Appendix E – Facility Reports - Buildings

City Hall - Exterior
 401 Grove Street
 Healdsburg, CA

Tayman Golf Course - Banquet Room
 927 S. Fitch Road
 Healdsburg, CA

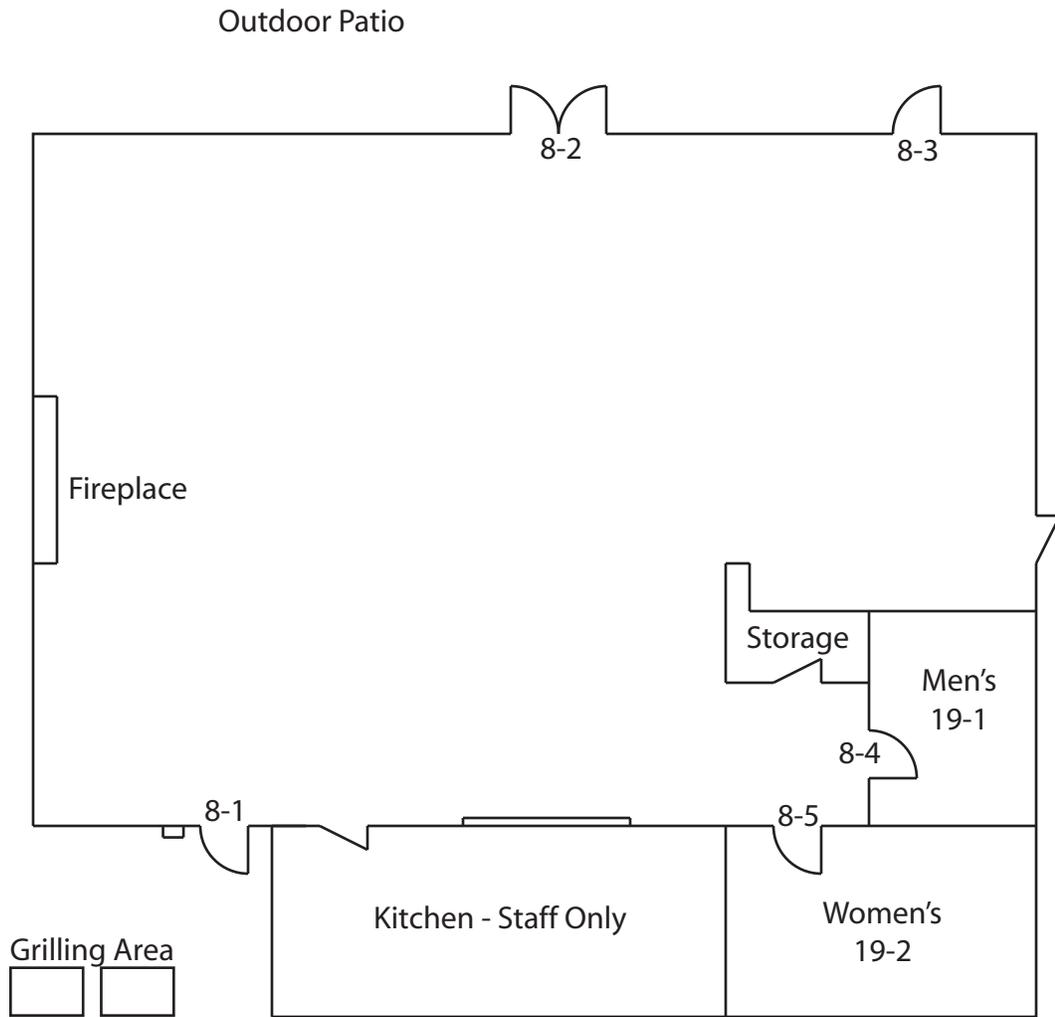
Install or modify permanent room signs		\$250
Notes: Provide tactile exit sign to accompany illuminated exit sign.		
State: 1011.3 #3		
Federal: -

Floor 1	
19 - 1	Multiple User Restroom
	Priority:2
Replace or reposition dispensers or mirrors	\$200
Notes: Mirror is mounted at 47-1/2" AFF (40" max). Coat hook on stall door is 68" AFF (48" max).	
State: 1115B.8.1, 1118B.5	
Federal: 4.19.6, A4.27	
Replace or reposition urinal	\$3,500
Notes: Urinal is 28-1/2" wide (32" min.)	
State: -	
Federal: 4.18.3	
Modify lavatory/counter clearances	\$3,500
Notes: Sink apron is 28.75" AFF (29" min.)	
State: 1115B.4.3 #2	
Federal: 4.19.2	
Modify stall partitions and doors	\$500
Notes: Compartment width is 57-1/2" (60" min).	
State: -	
Federal: 4.17.3	
Replace or reposition fixtures	\$1,000
Notes: Centerline of the toilet is 17-1/2" (18").	
State: 1115B.7.1.3	
Federal: 4.17.3

Floor 1	
19 - 2	Multiple User Restroom
	Priority:2
Modify stall partitions and doors	\$500
Notes: Width of stall compartment is 59.5" (60" min).	
State: -	
Federal: 4.17.3	
Replace or reposition dispensers or mirrors	\$200
Notes: Mirror is mounted 48" AFF. (40" min.)	
State: 1115B.8.1	
Federal: 4.19.6	
Modify lavatory/counter clearances	\$3,500
Notes: Sink apron is 28.5" (29" min.)	
State: 1115B.4.3 #2	
Federal: 4.19.2	
Replace or reposition dispensers or mirrors	\$200
Notes: Toilet paper dispenser is located 43" from the rear wall (36" max).	
State: 1115B.8.4	
Federal: 4.16.6	
Install sign	\$250
Notes: State signage not present.	
State: 1115B.6, 1117B.5.1 #1	
Federal: 4.30.4

Boys and Girls Club - Exterior & First Floor
515 Piper Street
Healdsburg, CA

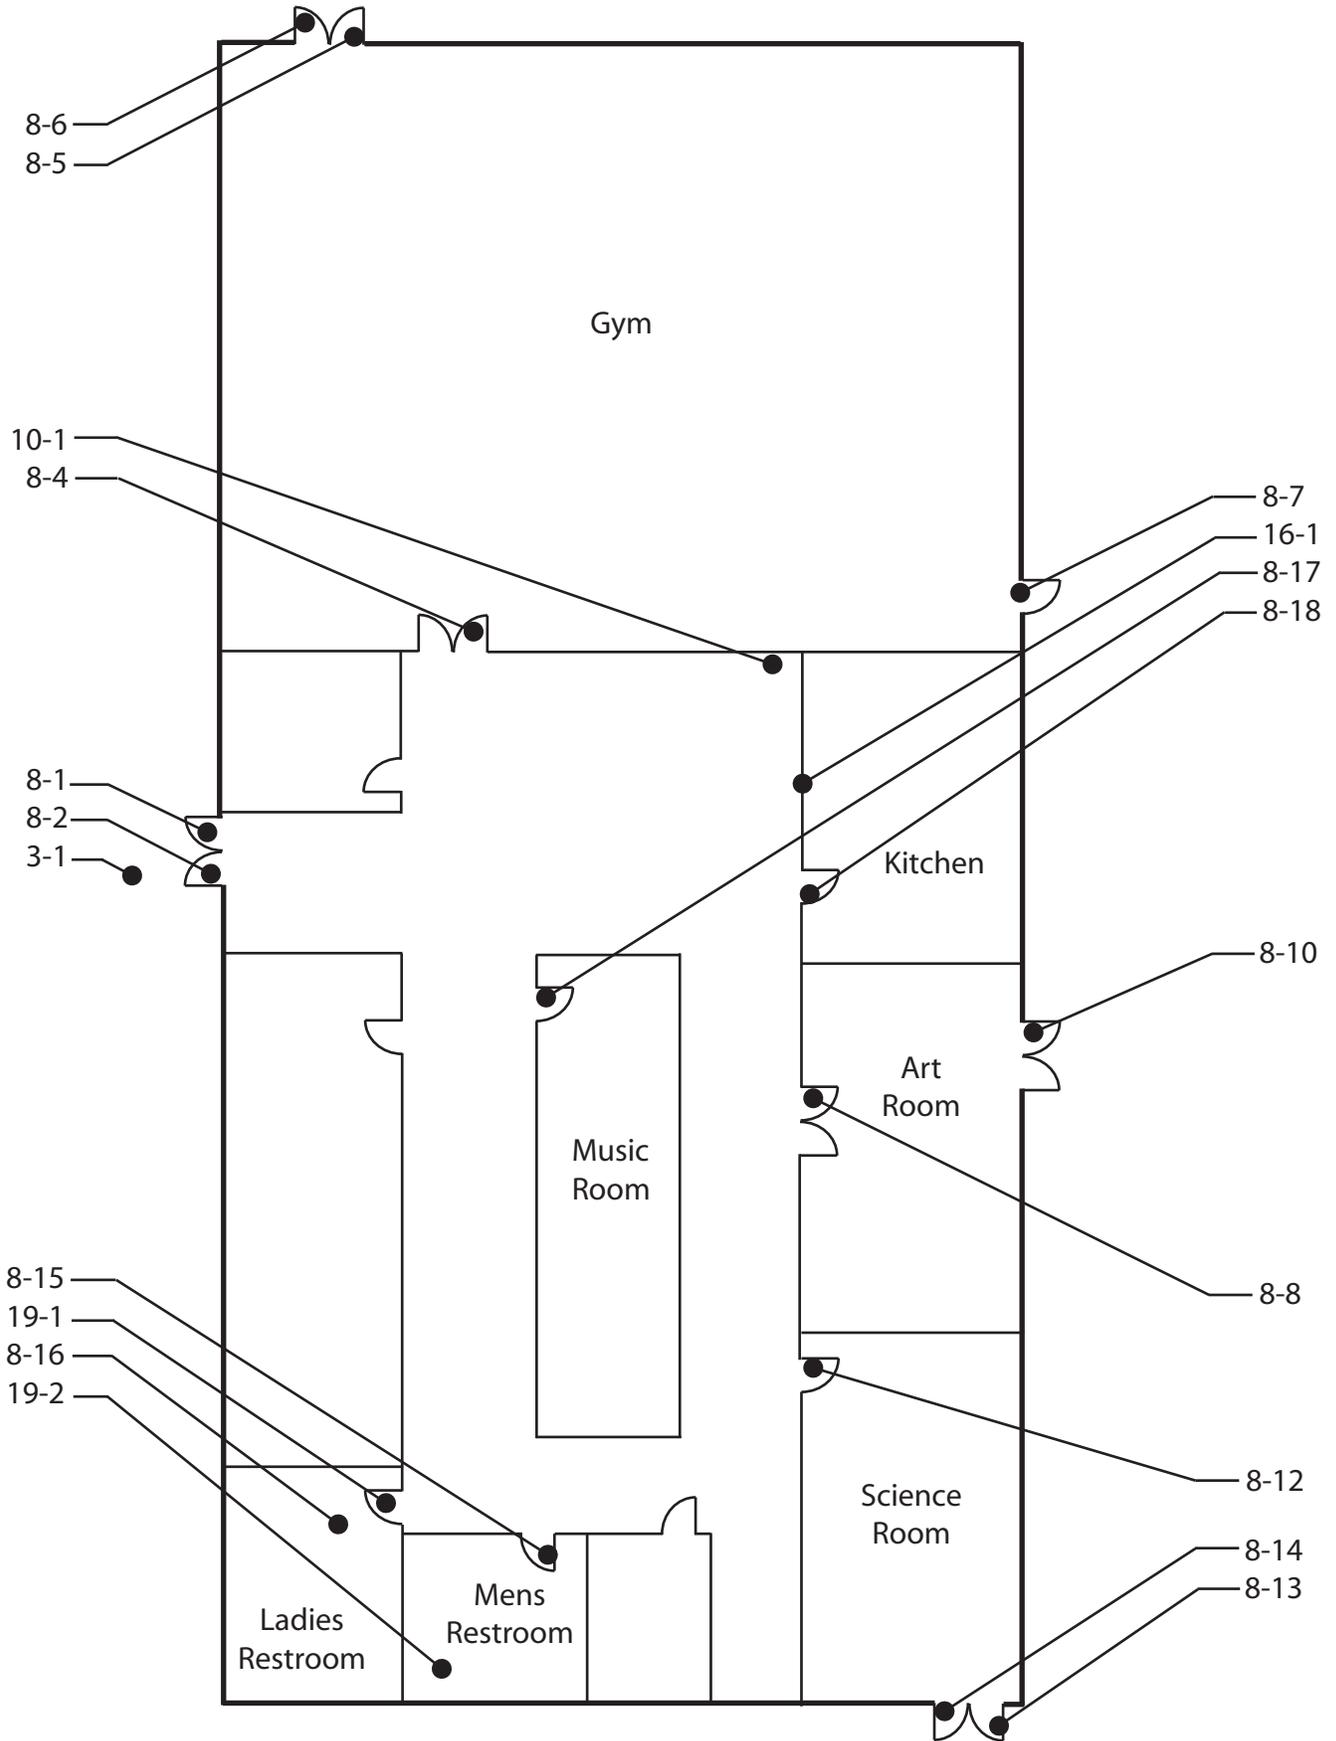
Floor 1		
19 - 2	Multiple User Restroom	Priority:2
Replace or reposition dispensers or mirrors		\$200
Notes: Mirror is mounted so bottom of reflecting surface is 47.25" (40" max) AFF.		
State: 1115B.8.1		
Federal: 4.19.6		
Replace or adjust water controls		\$500
Notes: Sink faucet control requires grasping and twisting.		
State: 1115B.8.3		
Federal: 4.19.5, 4.27.4		
Modify lavatory/counter clearances		\$1,500
Notes: Clear space beneath the lavatory sink is 26.25" (29" min).		
State: 1115B.4.3 #2		
Federal: 4.19.2		
Replace or reposition fixtures		\$1,000
Notes: Space from the wall to the centerline fo the water closet is 21.5" (18" absolute) AFF.		
State: 1115B.7.1.3		
Federal: 4.17.3		
Replace or reposition dispensers or mirrors		\$100
Notes: Seat cover dispenser is mounted 47.5" (40" max) AFF.		
State: 1115B.8.3		
Federal: 4.23.7		
Replace or modify grab bars		\$450
Notes: Grab bars are centered 34.5" (33" absolute) AFF. Side grab bar is positioned so the front end is 45" (54" min) from the back wall. Side grab bar is 14" (24" min) in front of the water closet.

State: 1115B.4.1 #3, 1115B.4.1 #3.1, 1115B.4.1 #3.2		
Federal: 4.17.6		
Replace or reposition dispensers or mirrors		\$200
Notes: Towel dispenser is mounted 48.5" (40" max) AFF.		
State: 1115B.8.3		
Federal: 4.23.7

Boys and Girls Club - Teen Center - Exterior & First Floor
515 Piper Street
Healdsburg, CA

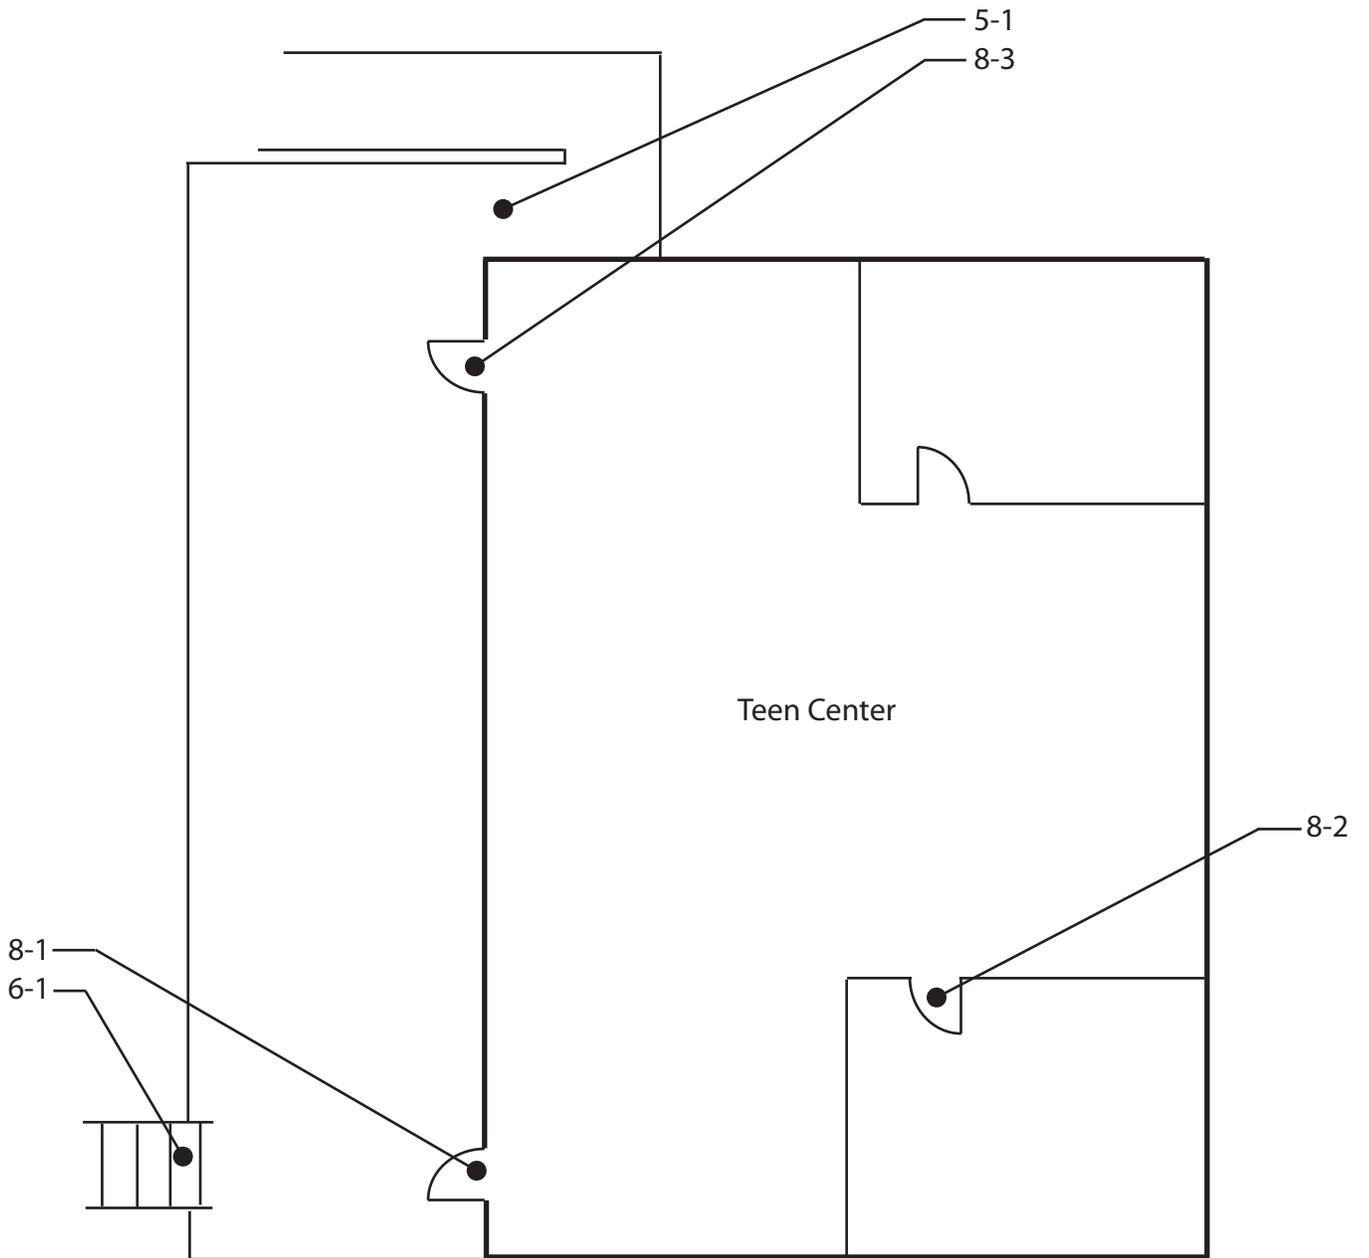
Floor 1		
8 - 1	Door/Gate	Priority: 1
Provide or modify door kickplate		\$100
Notes: Doorstop is mounted on kickplate.		
State: 1133B.2.6		
Federal: -		
Install or modify permanent room signs		\$250
Notes: There is an illuminated exit sign but tactile sign is not provided.		
State: 1011.3 #3		
Federal: -		
Enlarge door opening		\$3,500
Notes: Height of clear opening is 79" (80" min).		
State: 1008.11, 1133B.2.2		
Federal: 4.4.2		
8 - 2	Door/Gate	Priority: 2
Replace or adjust door hardware		\$300
Notes: Doorknob requires grasping and twisting.		
State: 1133B.2.5.2		
Federal: 4.13.9		
8 - 3	Door/Gate	Priority: 1
Install or modify permanent room signs		\$250
Notes: There is an illuminated exit sign but tactile sign is not provided.		
State: 1011.3 #3		
Federal: -		
Enlarge door opening		\$3,500
Notes: Height of clear opening is 79" (80" min).		
State: 1008.11, 1133B.2.2		
Federal: 4.4.2		
Adjust door closer		\$100
Notes: Operating effort is 19 lbs (5 lbs max).

State: 1133B.2.5		
Federal: 4.13.11

Museum - First Floor
221 Matheson Street
Healdsburg, CA

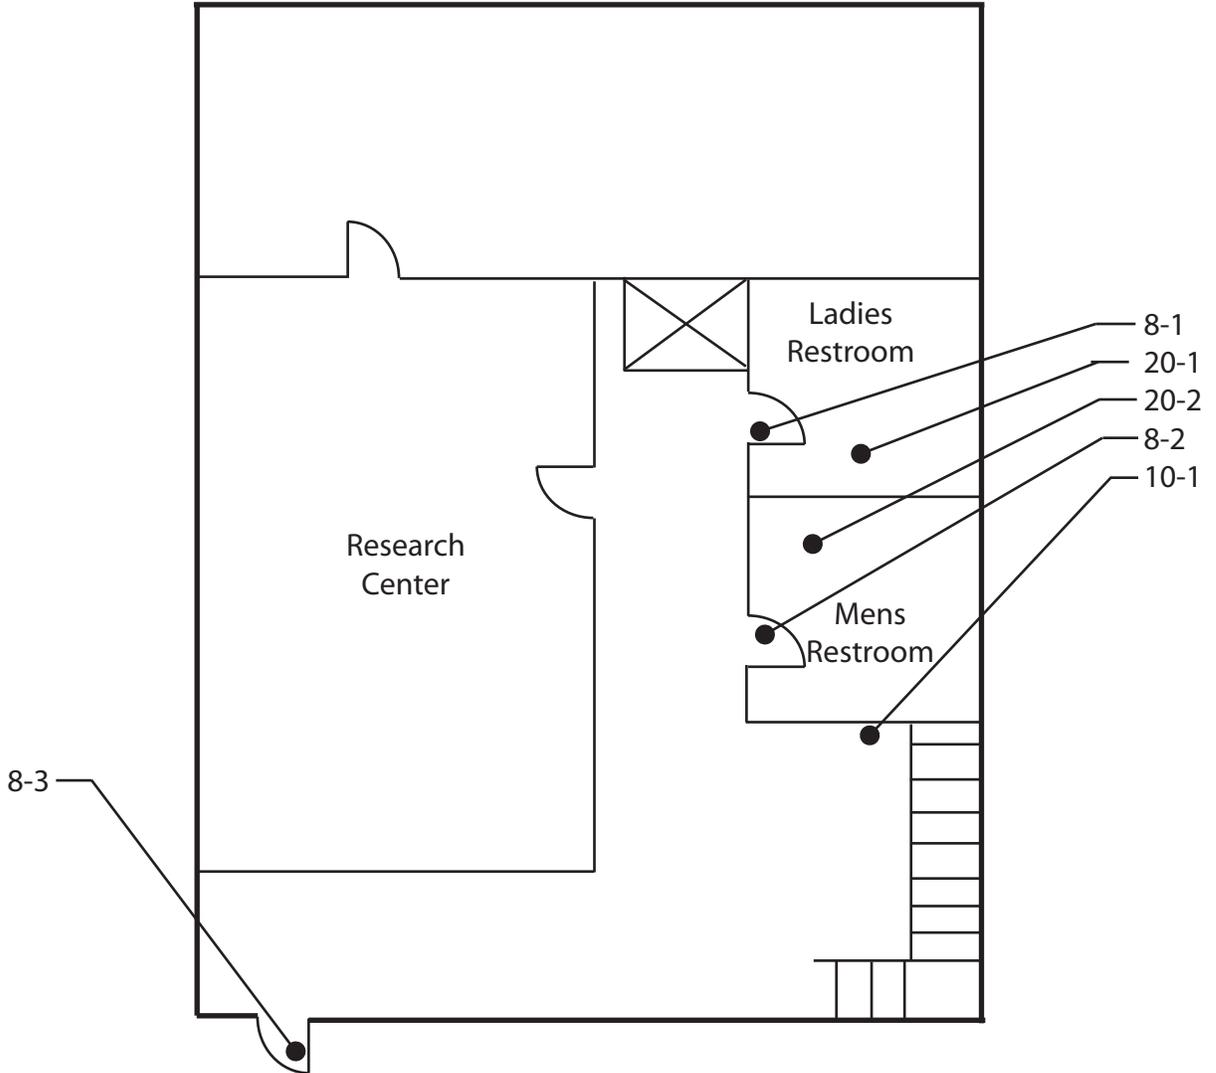
Floor 1		
20 - 2	Single User Restroom	Priority:2
Replace or reposition fixtures		\$1,000
Notes: Space from the wall to the centerline of the water closet is 19" (18" absolute).		
State: 1115B.4.1 #1		
Federal: 4.17.3

Museum - SecondFloor
 221 Matheson Street
 Healdsburg, CA

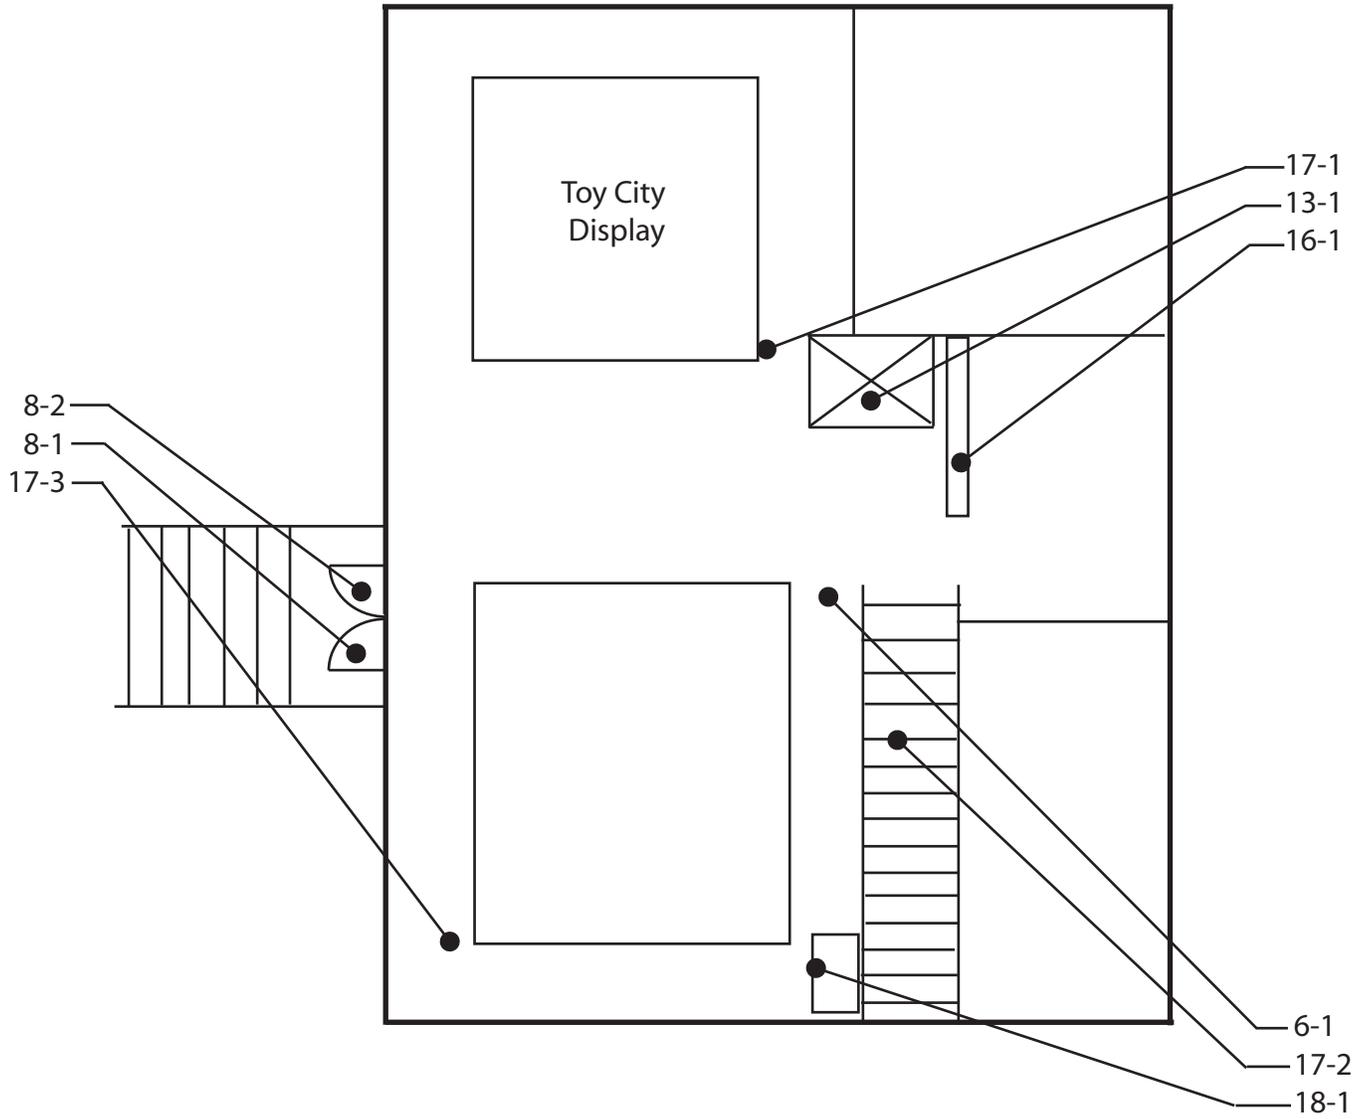
Floor 2		
13 - 1	Elevator	Priority:3
Adjust elevator controls and labeling		\$1,000
Notes: Voice communication is required to use the emergency communication system.		
State: 1116B.1.8		
Federal: 4.10.14		
Adjust or provide elevator signals and indicators		\$800
Notes: Audible warning devices are not provided for "up" direction or "down" direction.		
State: 1116B.1.13		
Federal: 4.10.4		
16 - 1	Transaction Counter	Priority:2
Provide an accessible counter		\$4,000
Notes: Transaction counter is 42.25" (28" to 34") AFF.		
State: 1122B.5		
Federal: 4.32.4		
17 - 1	Corridor / Aisle	Priority:2
Widen corridor		\$500
Notes: Distance between the Toy City display to the Doll Book Shelf is 26" (48" min). Relocate the doll book shelf to provide clear, accessible width.		
State: 1133B.3.1		
Federal: 4.3.3		
17 - 2	Corridor / Aisle	Priority:2
Widen corridor		\$500
Notes: Distance between the main display to the Wooden Toy Book Shelf is 27.5" (48" min). Relocate the wooden toy book shelf to provide clear, accessible width.

State: 1133B.3.1		
Federal: 4.3.3		
17 - 3	Corridor / Aisle	Priority:2
Widen corridor		\$500
Notes: Distance between the Snowman display to the Basket Display is 37.5" (48" min). Relocate the basket display to provide clear, accessible width.		
State: 1133B.3.1		
Federal: 4.3.3		
18 - 1	Room	Priority:2
Adjust shelving, storage, or work space		\$2,500
Notes: Bippart Family Kiosk - Knee space under the tabletop is 26.5" (27" min) high. Depth is 5.75" (19" min).		
State: 1122B.3		
Federal: 4.32.3
